Assessment of Dam Safety of Coal Combustion Surface Impoundments

Cleco Corporation

Brame Energy Center

March 14, 2011

Photo No. 54: Bottom Ash Pond – West embankment crest, looking south.

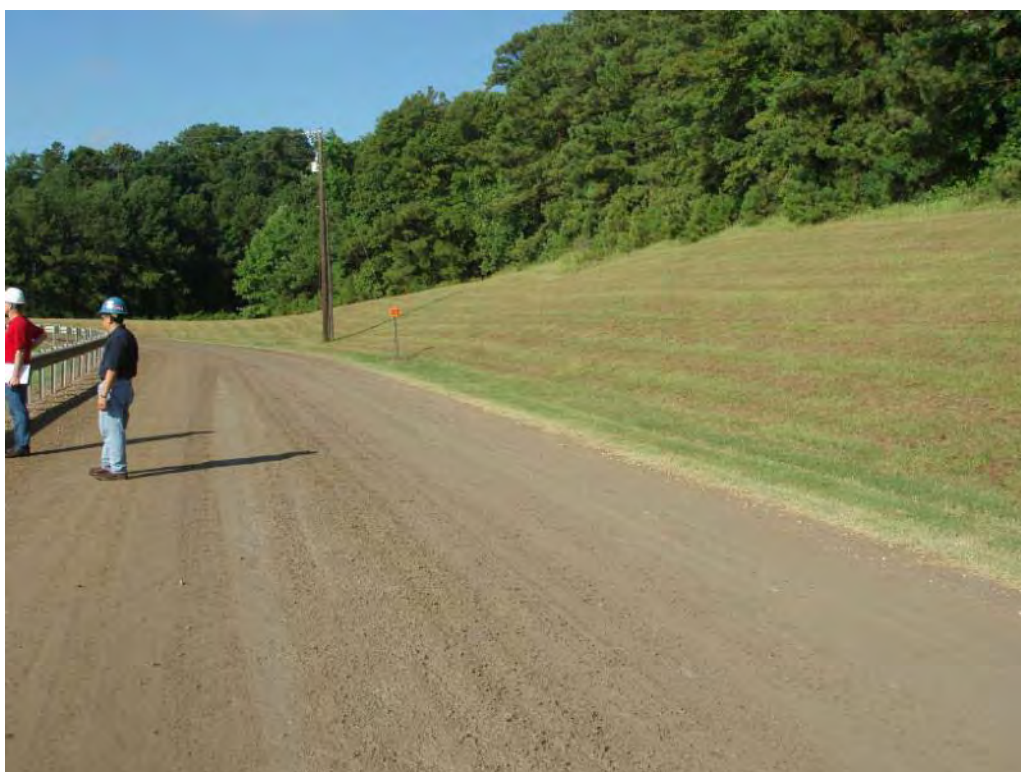
The south half of the west embankment crest, and the entire south and east embankment crests serve as primary haul roads for plant vehicles. The crest surface used as haul roads consists of compacted granular material (Photographs 54 and 60). The north half of the west embankment's crest and the north embankment crest have compacted granular material placed over a width of approximately eight feet to accommodate vehicle traffic. The balance of the crest is well vegetated with grass generally less than 4 inches in height.
